MEMORANDUM

RE: Additional Staff Comments on LU 2021-023 SUB Cedar Creek Gardens

Date: August 10, 2022

Figure 1: The existing public sanitary sewer lines are shown in red. Proposed public sanitary sewer lines are shown in blue. One or both lines may be extended to the south in the future to serve lots within the Urban Growth Boundary.

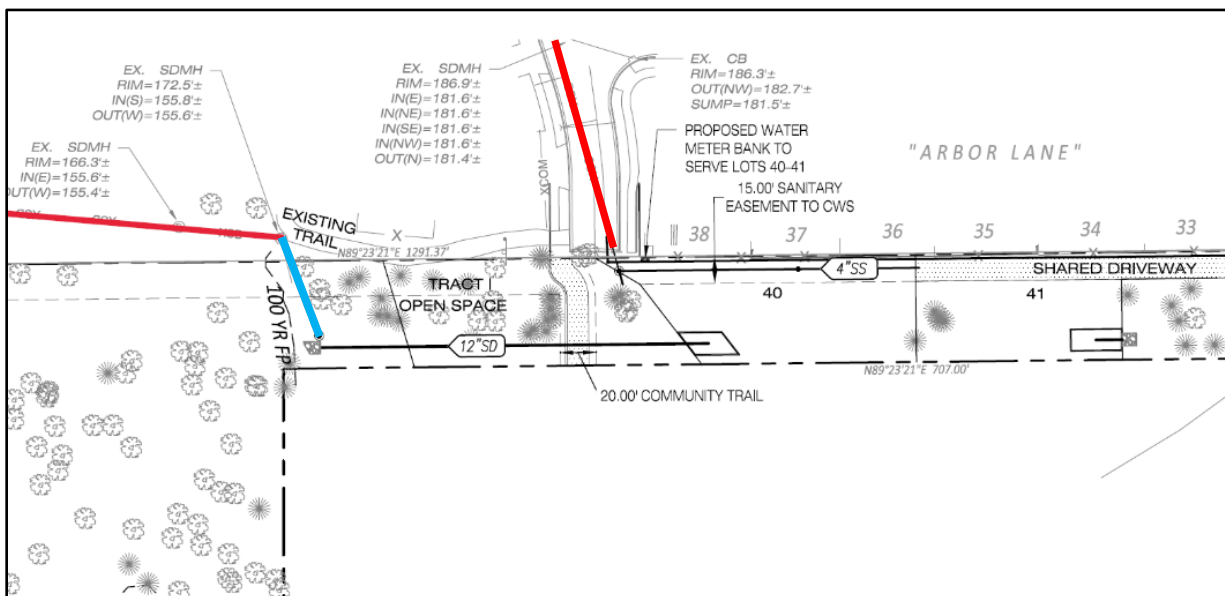
The City's preferred width for this section of the Community Trail is 12 ft. paved within a 20 ft. easement. As shown in Figure 1 below, a public sanitary sewer line is located within the Cedar Creek corridor to the west of Tract I and within Red Fern Drive. As one or both of these lines will be extended south in the future, the City's Engineering Department has requested the trail also serve as a maintenance access road. The 12 ft. wide trail meets City Engineering and Clean Water Services standards, and is consistent with the current proposal.

Prior to Final Plat Approval and Prior to Issuance of an Engineering Compliance Agreement, the trail within Tract I shall be designed to City of Sherwood Engineering Detail RD-64. The trail shall be designed to be accessed from SW Red Fern Dr.
